**PLANNED UNIT DEVELOPMENT
STAFF REPORT****Date: July 19, 2018****DEVELOPMENT NAME**

Balloon Park Subdivision

LOCATION4658 and 4660 Airport Boulevard
(North side of Airport Boulevard, 200'± West of North
University Boulevard)**CITY COUNCIL
DISTRICT**

CONTEMPLATED USEPlanned Unit Development Approval to amend a
previously approved Planned Unit Development to allow multiple buildings on a single building
site with shared access and parking between building sites.**TIME SCHEDULE
FOR DEVELOPMENT**

SITE PLAN

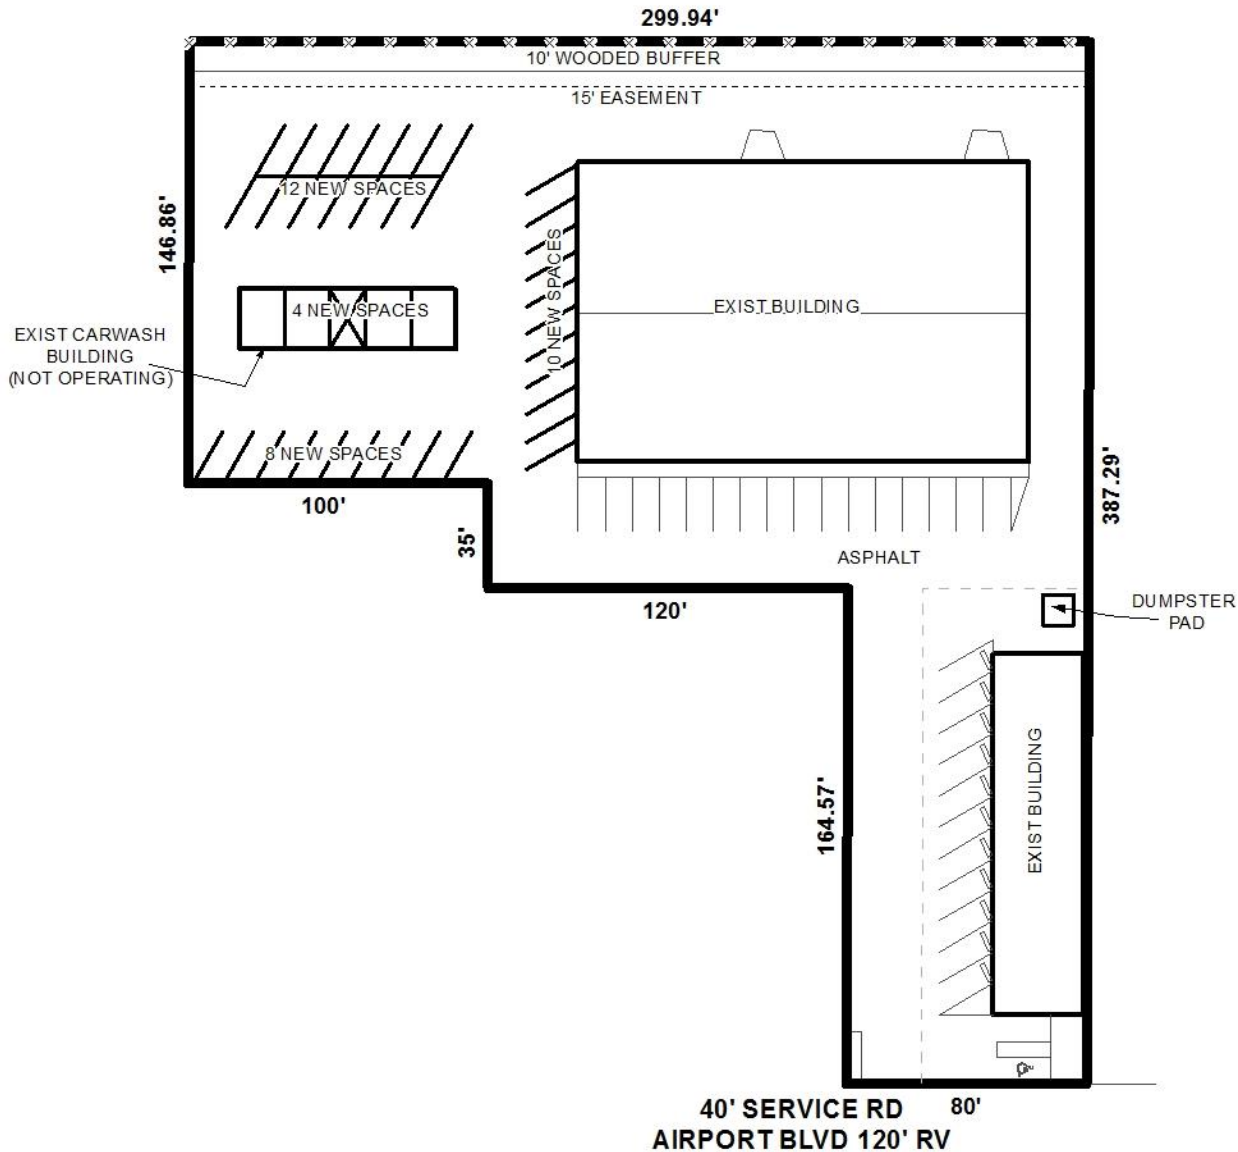
The proposed circulation shown in the PUD plan does not provide an opportunity to exit the site once a vehicle enters the northwest corner of the property (around the old carwash building). If access is available on adjoining property to circulate back to Airport Boulevard it should be shown on the plan, or the site layout will need to be reevaluated to provide better access. Assuming two-way traffic to the rear and eastern boundary of the site is not a realistic option.

The site plan indicates 36 new parking spaces with all but 2 being located in the rear of the site. It should be noted however, that the parking circulation does not clearly depict how traffic would exit the site. Traffic Engineering has expressed concern with the circulation pattern as well for the site; therefore, the applicant should consult with Traffic Engineering to insure that the circulation concerns are addressed.

The site plan illustrates the bays of the inoperable carwash to be utilized as 4 parking spaces. If it is the intent of the applicant to use this area as parking, the applicant should remove the carwash structure from the site. This would potentially allow one or two parking spaces to be relocated on the site to allow for improved traffic circulation.

A new dumpster pad is depicted at the rear of the proposed bar on Lot 2. It should be noted that new dumpsters must be connected to sanitary sewer and have either a privacy fence or masonry wall enclosure on three sides.

- 1) demolition of the inoperable carwash with appropriate permits;
- 2) coordination with Traffic Engineering to address circulation concerns;
- 3) provision of photometric plans showing full compliance with Sections 64-4.A.2., 64-6.A.3.c., and 64-6.A.8. of the Zoning Ordinance at the time of permitting; and
- 4) provision of a revised site plan prior to approval of permits.
